**FINAL TEXT RECOMMENDATIONS TO COUNCIL**  
**By**  
**REGULATORY/WARNING SIGNS TECHNICAL COMMITTEE**

**National Committee on Uniform Traffic Control Devices**

**TOPIC:** Section 2A.18 and Section 6F.03 Mounting height of signs

**REVISED**  
**Figure 2A-1. Examples of Heights and Lateral Locations of Signs for Typical Installations**

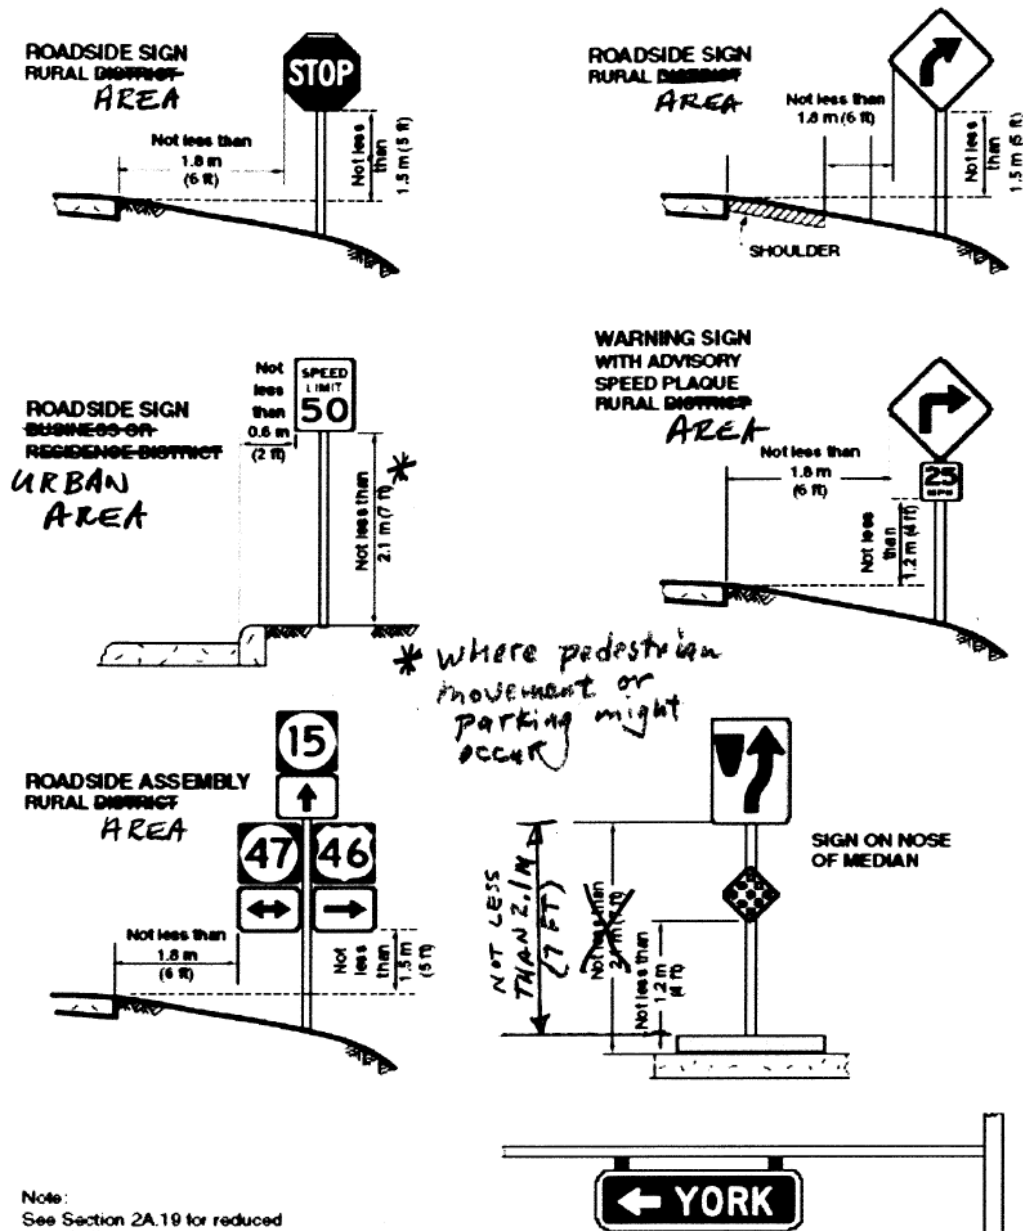
Figure 2A-1 indicates a 7' mounting height measured from the top of the curb in one detail and measured from the roadway surface where used in the median.

4. Change 2A.18 so it is clear that this is vertical dimension.
5. Change Figure 2A-1 to indicate 7’ clearance from the top of curb where pedestrians might be. Change Figure 2A-1 headings from ROADSIDE SIGN RURAL DISTRICT to read ROADSIDE SIGN RURAL AREA. Change ROADSIDE SIGN BUSINESS OR RESIDENCE DISTRICT to read ROADSIDE SIGN URBAN AREA. Change ROADSIDE ASSEMBLY RURAL DISTRICT to read ROADSIDE ASSEMBLY RURAL AREA. Change the sign on median nose to indicate vertical measurement is from top of curb to bottom of sign.

Change Figure 2A-1 to indicate 7' clearance from the top of curb where pedestrian movement or parking might occur. Change Figure 2A-1 headings to read ROADSIDE SIGN RURAL DISTRICT to read ROADSIDE SIGN RURAL AREA for both warning and regulatory signs details. Change ROADSIDE SIGN BUSINESS OR RESIDENCE DISTRICT to read ROADSIDE SIGN URBAN AREA for both regulatory and warning sign details. Change ROADSIDE ASSEMBLY RURAL DISTRICT to read ROADSIDE ASSEMBLY RURAL AREA. Change the sign on median nose to indicate vertical measurement is from top of curb to bottom of sign.

**Figure 2H-3. Height and Lateral Position of Signs Located Within Recreational and Cultural Interest Areas**

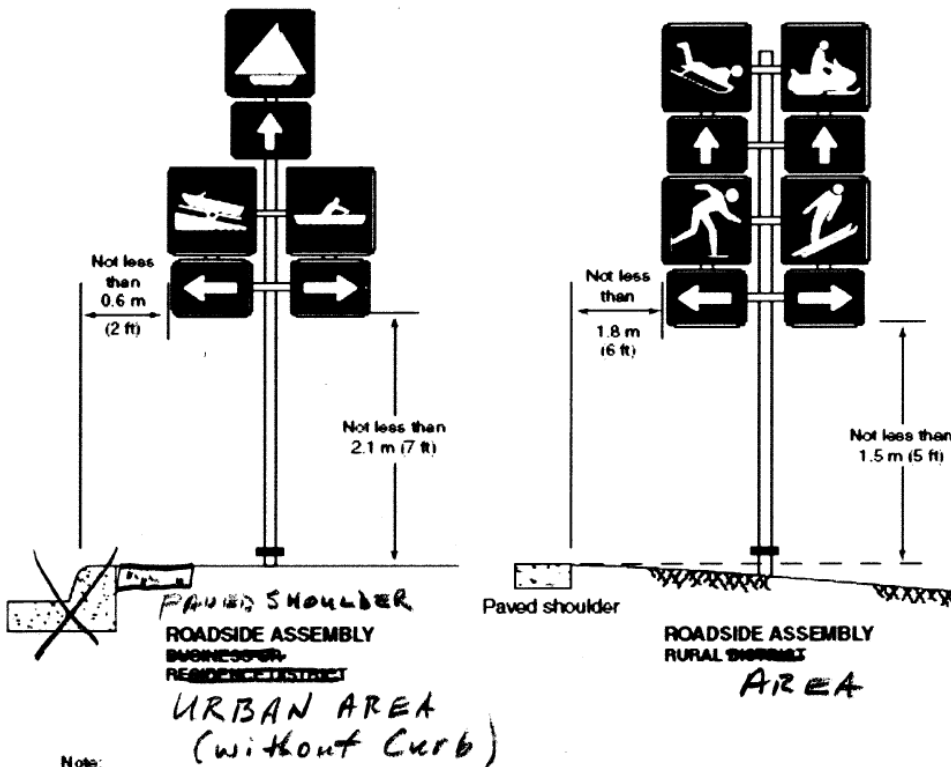
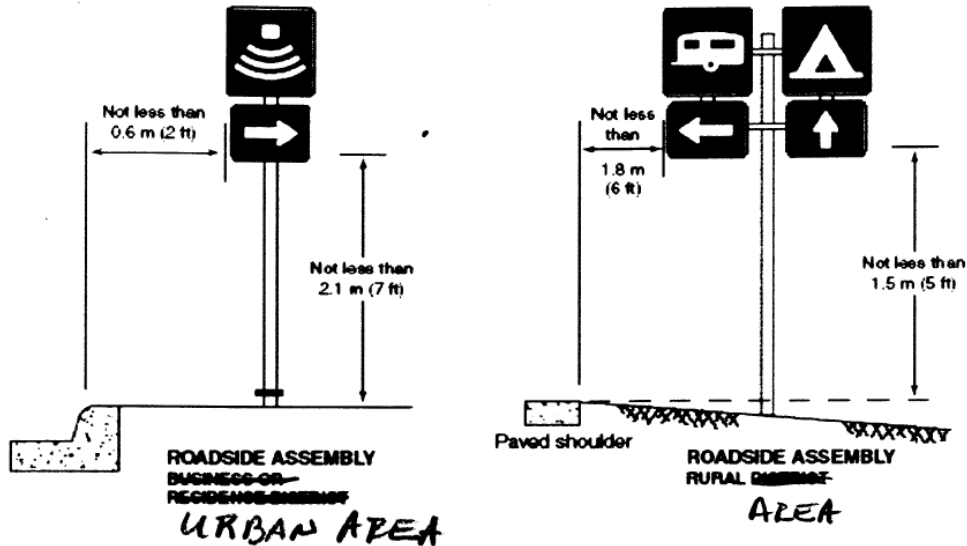
6. Change Figure 2H-3 headings from RURAL DISTRICT to read RURAL AREA and BUSINESS OR RESIDENCE DISTRICT to read URBAN AREA on the details. Remove the curb and gutter from the lower left detail of Figure 2H-3 to illustrate an urban detail without curb and gutter. **The G/MI Technical committee approved this change on 1-19-06**

Change Figure 2H-3 headings from RURAL DISTRICT to read RURAL AREA and BUSINESS OR RESIDENCE DISTRICT to read URBAN AREA on all the details. Omit the curb on the bottom left detail to illustrate an urban area without curb.

**Figure 6F-1. Height and Lateral Location of Signs—Typical Installations**

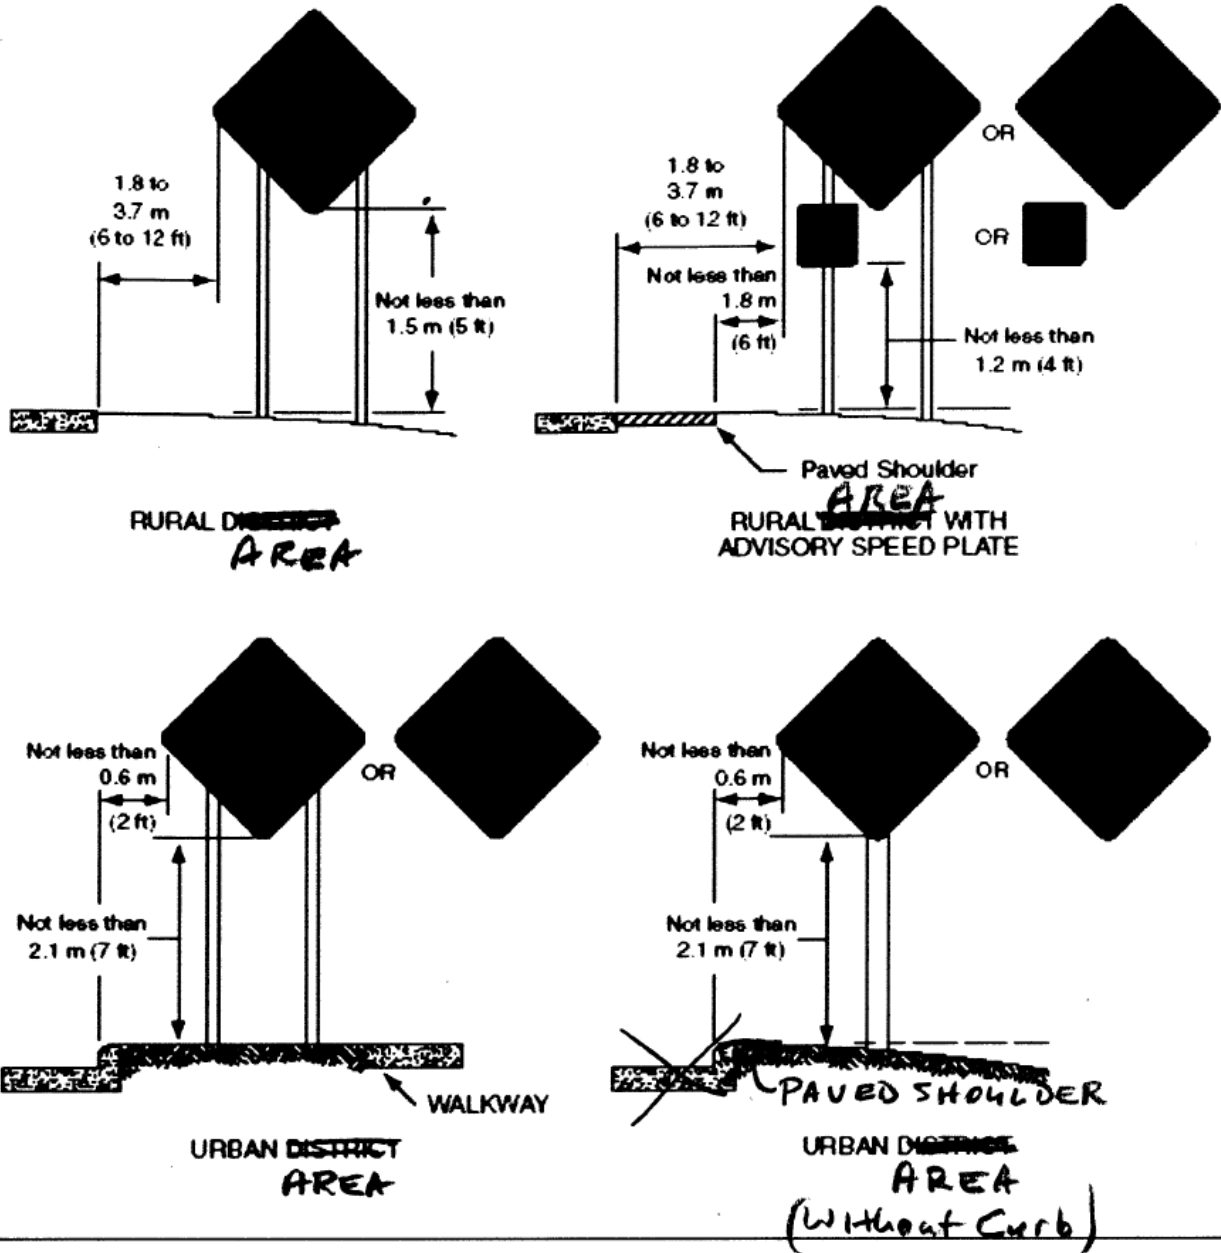
7. Change Figure 6F-1 headings from RURAL DISTRICT to read RURAL AREA. Change the detail on the left from URBAN DISTRICT to URBAN AREA. Change the detail on the right from URBAN DISTRICT TO URBAN AREA WITHOUT WALKWAY, and delete the curb in order to match the text in 6F.03. **The Temporary Traffic Control Technical committee has approved this change on 1-19-06.**

Change Figure 6F-1 headings from RURAL DISTRICT to read RURAL AREA and change the detail on the left from URBAN DISTRICT to URBAN AREA. Change the detail on the right from URBAN DISTRICT TO URBAN AREA WITHOUT WALKWAY (delete the curb).
